Work Order ID 135099

Item Name: Crosstube Turning Detail

DRAWING NO. D206-667-141	TITLE CROSSTUBE ASS'Y (206B HIGH FWD)	REV. C	DART AEROSPACE LTD ENGINEERING ORDER		D.E.O. NO. D206-667-141-C-1	SHEET NO. SHEET 1 OF 1	SCALE NTS
DRAWN 90	CHECKED ASS	MFG. APPR. [Signature]	APPROVED [Signature]		DE APPR. [Signature]		
DATE 11.07.15	DATE 11.07.20	DATE 11.07.21	DATE 11/07/21		DATE 11.07.21

DRAWING NO. D206-667-141		TITLE CROSSTUBE ASS'Y (206B HIGH FWD)		REV. C		DART AEROSPACE LTD ENGINEERING ORDER		D.E.O. NO. D206-667-141-C-2		SHEET NO. SHEET 1 OF 1		SCALE NTS	
DRAWN AJS		CHECKED		MFG. APPR.		APPROVED		DE APPR.		DATE		DATE	
DATE 12.08.02		DATE 12.08.02		DATE 12.08.02		DATE 12.08.02		DATE 12.08.02		DATE 12.08.02		DATE 12.08.02

DETAIL P
BONDING STRAP INSTALLATION 2 PL

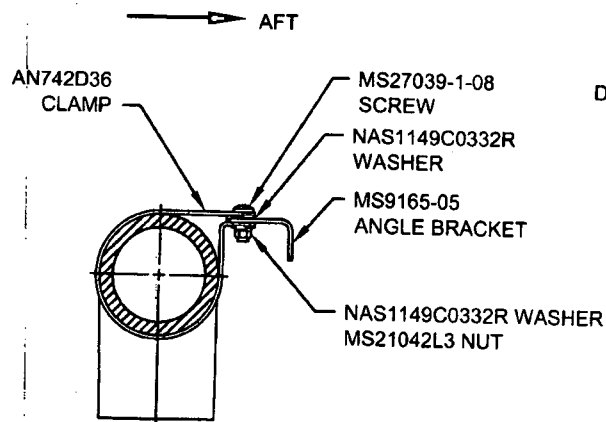
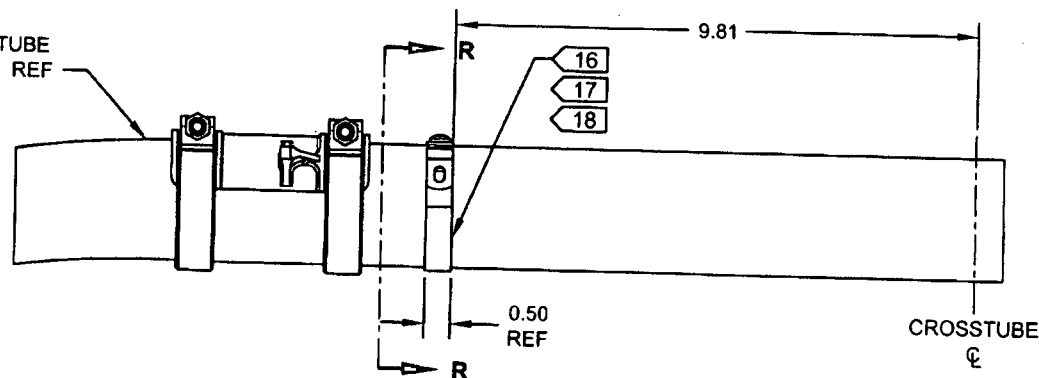
ADD ELECTRICAL GROUNDING STRAP

ITEM	QTY	PART NUMBER	DESCRIPTION
1	X	D206-667-141	CROSSTUBE ASSEMBLY (206B HIGH FWD)
10	2	AN742D36	CLAMP
11	2	MS9165-05	ANGLE BRACKET
12	2	MS21042L3	NUT (OR MS21042-3)
13	2	MS27039-1-08	SCREW
14	4	NAS1149C0332R	WASHER (OR AN960C10L)

- 16) MASK AREA UNDER CLAMP PRIOR TO PAINTING
- 17) SEAL EDGES WHERE AN742D36 CLAMP MEETS WITH THE CROSSTUBE USING SIKAFLEX-241/-291 OR MIL-S-8802 CLASS B2 OR PROSEAL 890 SEALANT
- 18) PERFORM RESISTANCE CHECK TO ENSURE MAX RESISTANCE IS 10 MILLIOHMS
